SMYRNA MUNICIPAL PLANNING COMMISSION

MEETING MINUTES FEBRUARY 6, 2025

2. Janet Ibrahim - **Requesting one month deferral**
Rocky Fork Road
Owner / Developer: Janet Ibrahim

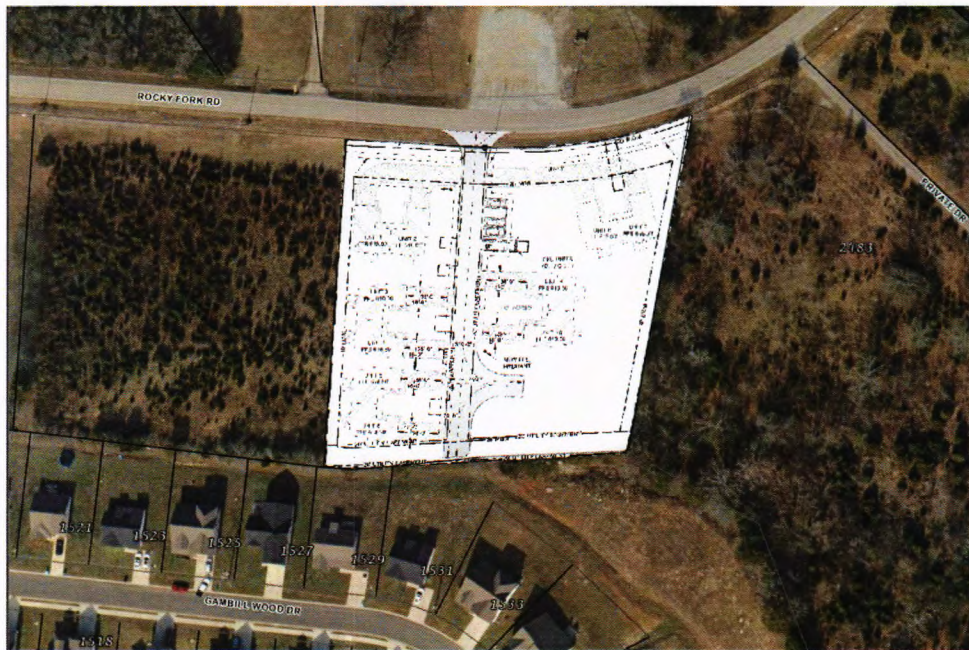
3. How is the drainage going to the detention pond? Please show on the plans.
4. Provide documentation where the developer has permission from the adjacent property owner to extend the sewer through the easement.

5. Submit architectural elevations to match what is shown on the approved PRD.
6. Landscape and storm structures cannot overlap. Out fall running through the buffer.

7. Provide parking details.
8. Show all existing utilities around offsite sewer tie-in.
9. The maximum run of a sewer main from manhole to manhole is 350 feet.

16. Why are existing trees being shown on top of sewer lines?
17. No trees are allowed within sewer easements.
18. Show all proposed easements and offsite sewer easements.

1. Sewart's Landing Outparcels 4 & 5
 Allan Sewart Way
 Owner / Developer: Equitable Property Company

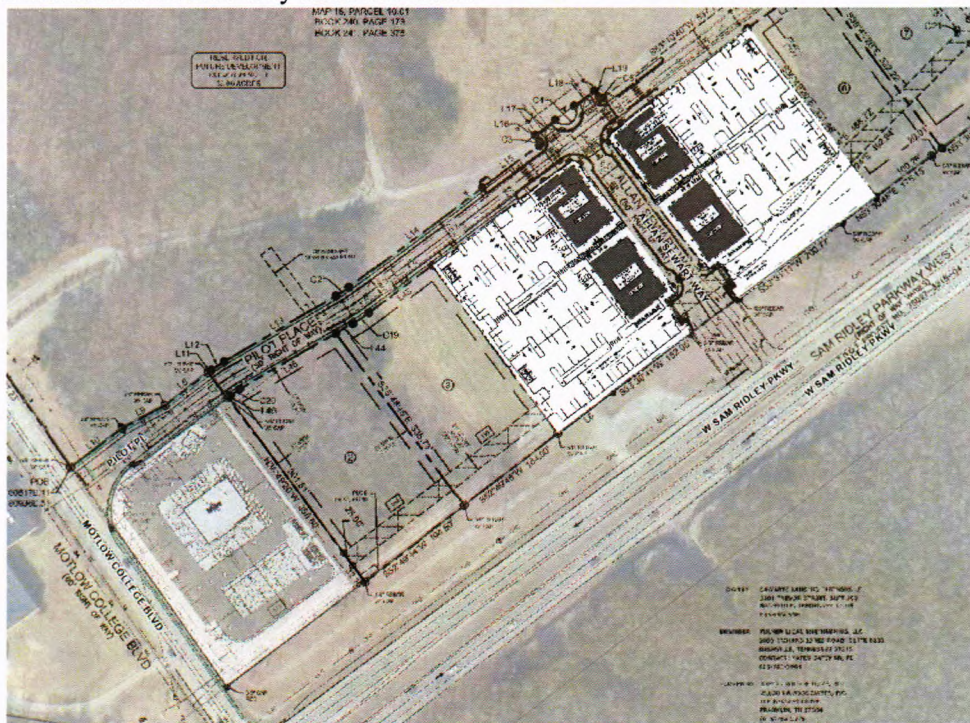
Landscape plan shows a variety of street trees and ornamental trees planted throughout the site to be developed and along all right-of-ways. Nearly all islands around the parking areas contain a mixture of shrubs and trees. Trees along Sam Ridley Parkway W. are shown within the right-of-way and staff will need to be provided approval from TDOT to plant vegetation within their right-of-way.

1. Please provide documentation from TDOT for landscaping within the right-of-way.
2. The minimum road width is 26' for any building over 30' tall.
3. The required minimum fire flow is 1,750 at 20 PSI. Buildings A & C will require a fire sprinkler system. No FDC's are allowed on the building and a fire hydrant must be within 100' of the FDC.

2. Spring Branch, Phase 2
Ledbury Drive / Salinger Way
Owner / Developer: Green Trails

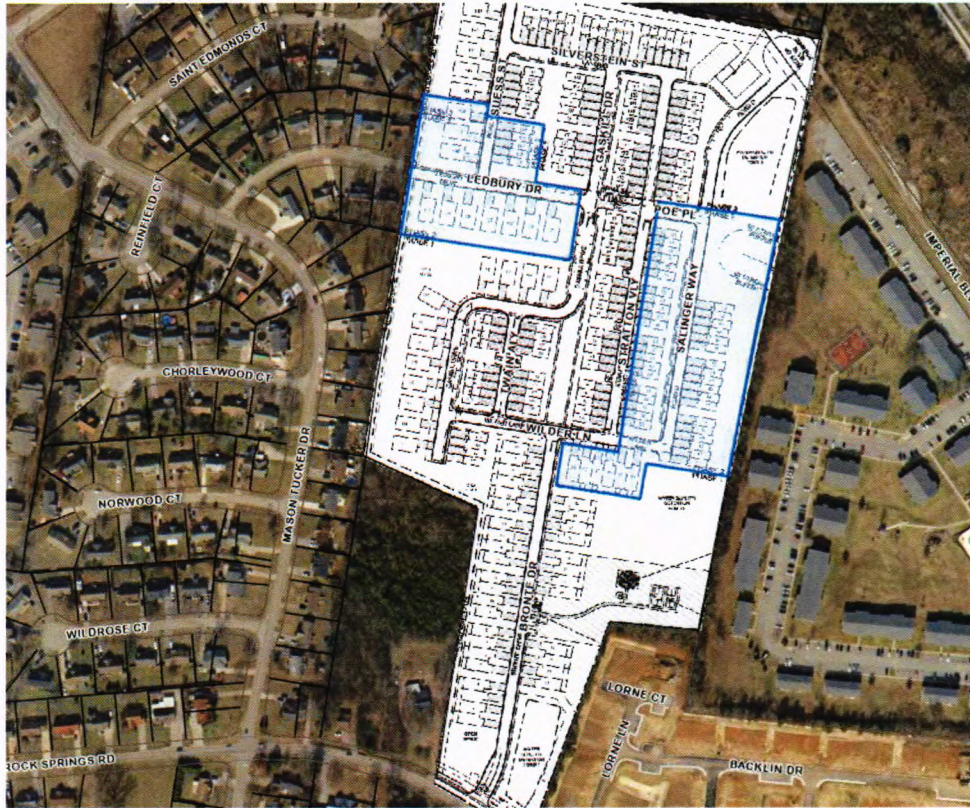
1. The Town is not able to provide fire flow protection for units 135-154 until the Imperial Boulevard improvements are made unless the units are sprinkled.
